**TO:** Sydney Central City Planning Panel meeting of 10 June 2021

**SUBJECT:** 14-22 Mary Street AUBURN NSW 2144

**APPLICATION No:** DA2020/0542

Figure 5 – Design Excellence Panel mark-ups of amended design

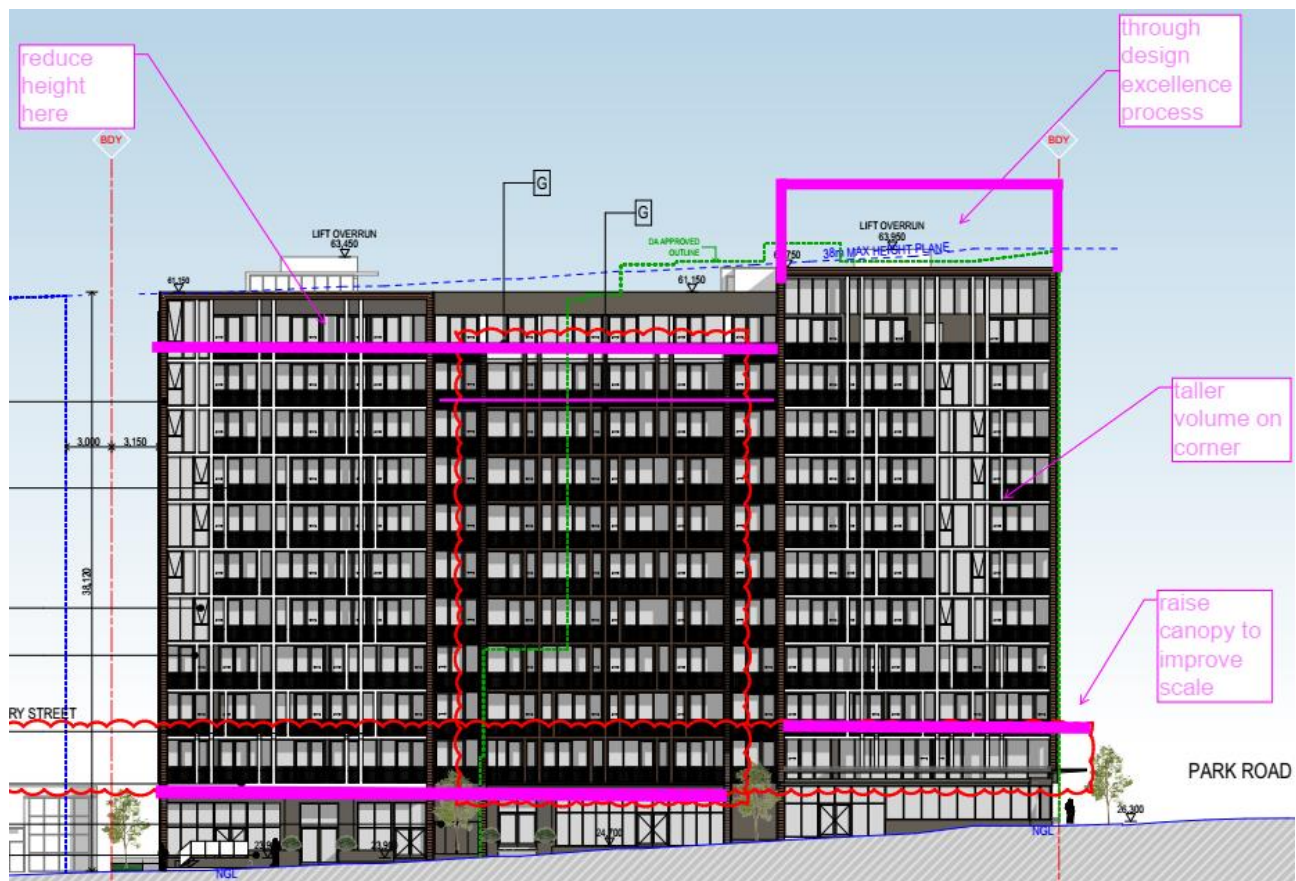
The DEP assessed the original proposal and raised a number of concerns that were included in the letter sent to the applicant on 3 February 2021. Amendments were made to the proposal attempting to address the DEP's issues. One of the amendments was to modulate the Mary Street façade to further reduce the bulk and scale of the building. As can be seen in **Figure 4**, the central element has been lowered and a darker colour used for differentiation. Notwithstanding this, in their review of the amended plans, the DEP were still not prepared to support the proposal. Whilst no written comments were provided, mark-ups were made to the plans (see **Figure 5**). These are significant amendments that cannot be required by condition. In any event it is considered that the reduction in height would be difficult to justify as it would result in large parts of the building being well below the permitted height and the reduction in floor space would also reduce the FSR to well below that permitted. The potential reallocation of floor space to the corner indicated on the mark-up is problematic as the noted 'design excellence process' is not available to the subject site and the impacts of the additional height may be unreasonable.

It is considered that the amended proposal allows for a reasonable variation in the building heights across the site and that the design will have an appropriate appearance in the surrounding streetscapes.

As noted above, the comments of the Design Excellence Panel (DEP) in relation to height are not agreed with and it is considered that the amended scheme introduces a suitable variation in perceived height and bulk at the Mary Street frontage (see **Figure 4**).
